UNITED STATES PATENT AND TRADEMARK OFFICE

| APPLICATION NO.  | FILING DATE   | FIRST NAMED INVENTOR | ATTORNEY DOCKET NO. | CONFIRMATION NO. |           |               |            |       |
|--|---------------|----------------------|---------------------|------------------|-----------|---------------|------------|-------|
| 10/510,351   | 10/06/2004    | Ernest R. Bodnar     | 1120U106            | 9530             |           |               |            |       |

| <b>Office Action Summary</b> | <b>Application No.</b> | <b>Applicant(s)</b> |  |

Title : STEEL STUD WITH OPENINGS AND EDGE FORMATIONS  
AND METHOD

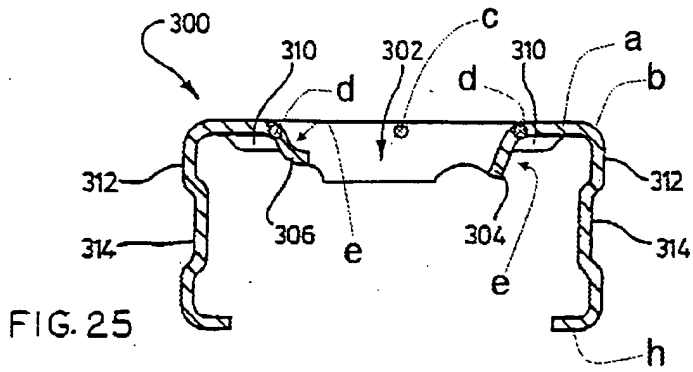
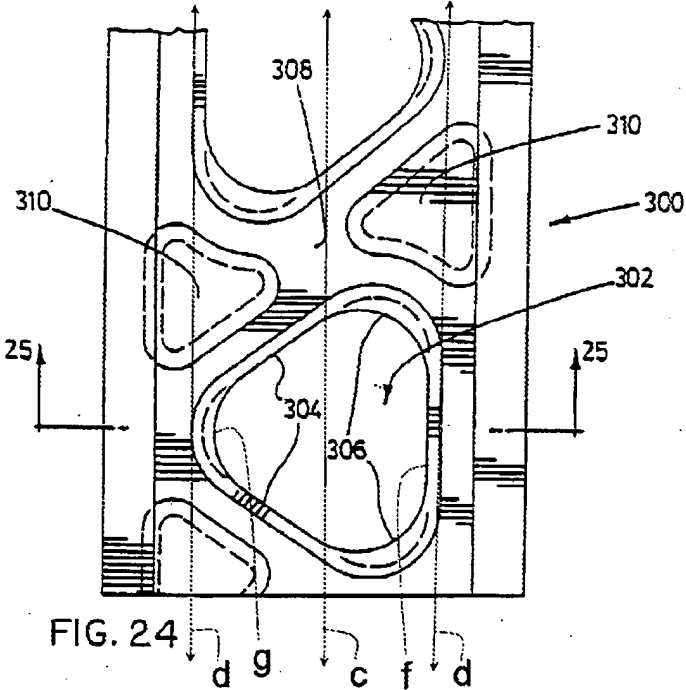
Regarding claim 7, Folsom '781 discloses the structure discussed above, but does not disclose openings formed in said web at opposite ends of each said strut to restrict heat transfer through said member. However, Schnitzer '871 discloses a steel having opening (42) formed in a web (22) at opposite ends of each strut (24) to provide a light weight structural member. Therefore, it would have been obvious to a person having ordinary skill in the art at the time of the Applicant's invention to modify the structure of Folsom '781 to have holes on opposite ends of each strut as taught by Schnitzer '871 to provide an even more lightweight structure.

Regarding claim 28, Folsom '781 discloses the method discussed above, and further discloses struts (7) formed extending across said web between said openings and forming slots, but does not disclose slots in said web adjacent each end of each said strut. However, Schnitzer '871 discloses a steel having slots (42) formed in a web (22) adjacent each ends of each strut (24) to provide a light weight structural member. Therefore, it would have been obvious to a person having ordinary skill in the art at the time of the Applicant's invention to modify the structure of Folsom '781 to have slots on opposite ends of each strut as taught by Schnitzer '871 to provide an even more

Bodnar '625

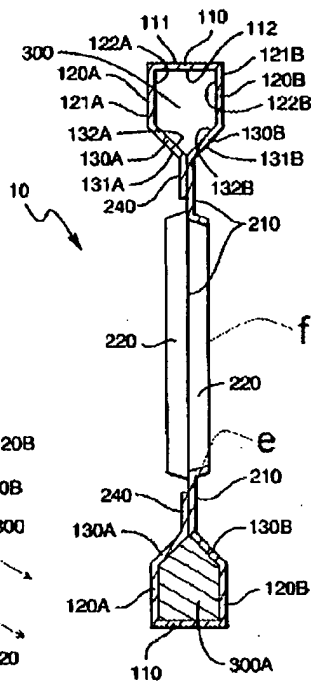
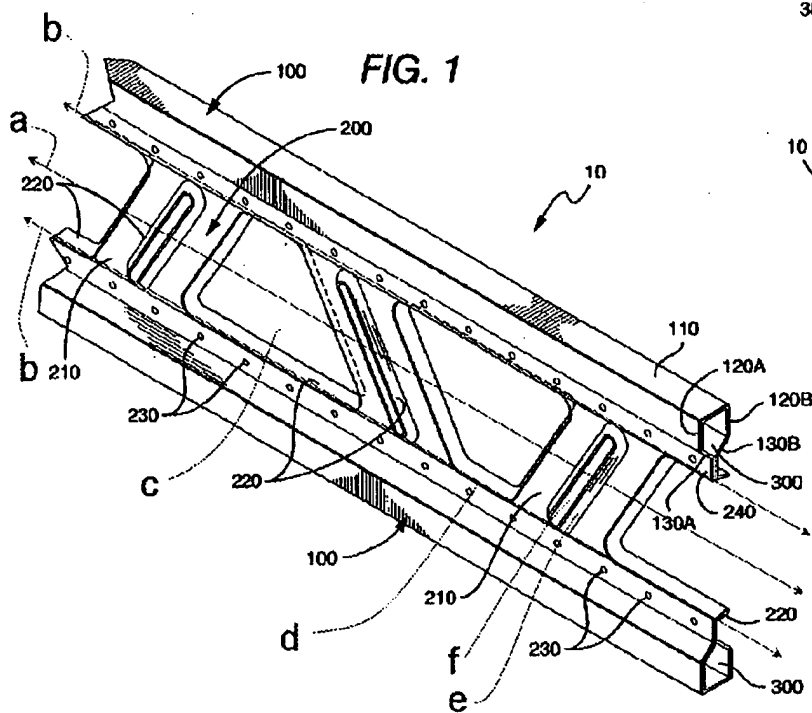
Regarding claim 1, Bodnar '625 in Figures 24-25 discloses a steel member for use in supporting structures and having reduced heat transfer characteristics as compared with solid web studs, and characterized by a web (a) defining side edges and an axis (c); a flange (312) on at least one side edge; openings (302) through said web at spaced intervals therealong, of predetermined size and profile, at least a side portion (304, 306) of said web being removed from said opening and remaining attached integrally to said web, and being bent away from said web along axes (d) parallel to said web axis (c).

Regarding claim 3, Bodnar '625 discloses the structure discussed above and further discloses that said side portion (304, 306) defines a channel shape (e) extending along an axis parallel to said web axis.

Regarding claim 4, Bodnar '625 discloses the structure discussed above and further discloses that said openings (302) are of a shape defining a linear side edge (f), and an arcuate side edge (g), said side portion (304, 306) of said web being integral with said linear side edge (f).

Regarding claim 5, Bodnar '625 discloses the structure discussed above and further discloses that there are two said flanges (312) one on each side of said web, being formed at normal to said web, and lips (h) formed along said flanges and normal to said flanges.

Regarding claim 6, Bodnar '625 discloses the structure discussed above and further discloses that openings (302) are arranged in an alternating orientation and struts (308) are defined between said openings, said struts extending diagonally across said member.

Regarding claim 26, Bodnar '625 in Figures 24-25 discloses a steel member having a web (a), side edges, and a flange (312) along at least one said side edge and openings (302) through said web wherein said openings (302) are formed in said web at spaced intervals therealong, with one of said openings leaving a side portion of metal attached to said web forming an edge flange (304, 306) along said at least one side edge of said web and forming said side portion out of the plane of said web wherein said side portion is bent along bend lines (d) parallel to the web axis (c). Therefore, the method steps set forth in claim 26 of forming the steel member with the above said structure and bending side portions would have been an obvious if not inherent method of making the steel member having the same structure.

Meyer '217

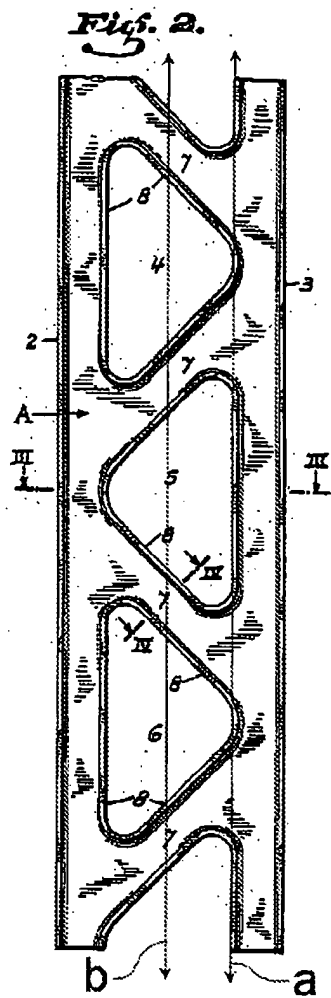
Regarding claim 1, Meyer '217 in Figures 1 and 2 discloses a steel member for use in supporting structures and having reduced heat transfer characteristics as compared with solid web studs, and characterized by a web (210) defining side edges and an axis (a); a flange (120a, 110) on at least one side edge; openings (c) through said web at spaced intervals therealong, of predetermined size and profile, at least a side portion (d, 220) of said web being removed from said opening and remaining attached integrally to said web, and being bent away from said web along axes (b) parallel to said web axis (a).

Regarding claim 2, Meyer '217 discloses the structure discussed above and further discloses depressions (e) formed in said web at spaced intervals, and an opening (f) formed in said depressions to reduce heat transfer.

Folsom '781

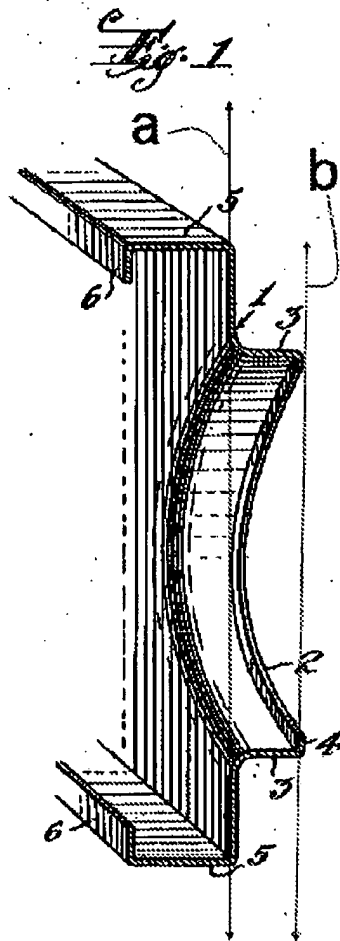
Regarding claim 1, Folsom '781 in Figures 1 and 2 discloses a metal member for use in supporting structures and having reduced heat transfer characteristics as

compared with solid web studs, and characterized by a web (A) defining side edges and an axis (b); a flange (3) on at least one side edge; openings (4-6) through said web at spaced intervals therealong, of predetermined size and profile, at least a side portion (8) of said web being removed from said opening and remaining attached integrally to said web, and being bent away from said web along axes (a) parallel to said web axis (b), but does not disclose that the member is steel. However, it would have been obvious to one having ordinary skill in the art at the time of invention to use steel, since it has been held to be within the general skill of a worker in the art to select a known material on the basis of its suitability for the intended use as a matter of obvious design choice. *In re Leshin*, 227 F.2d 197, 125 USPQ 416 (CCPA 1960)

Regarding claim 6, Folsom '781 discloses the structure discussed above and further discloses that said openings (406) are arranged in an alternating orientation and struts (7) are defined between said openings, said struts extending diagonally across said member.

Regarding claim 26, Folsom '781 discloses a steel member having a web (A), side edges, and a flange (3) along at least one said side edge and openings (4-6) through said web wherein said openings (4-6) are formed in said web at spaced intervals therealong, with one of said openings leaving a side portion of metal attached to said web forming an edge flange (8) along said at least one side edge of said web and forming said side portion out of the plane of said web wherein said side portion is bent along bend lines (a) parallel to the web axis (b). Therefore, the method steps set forth in claim 26 of forming the steel member with the above said structure and bending
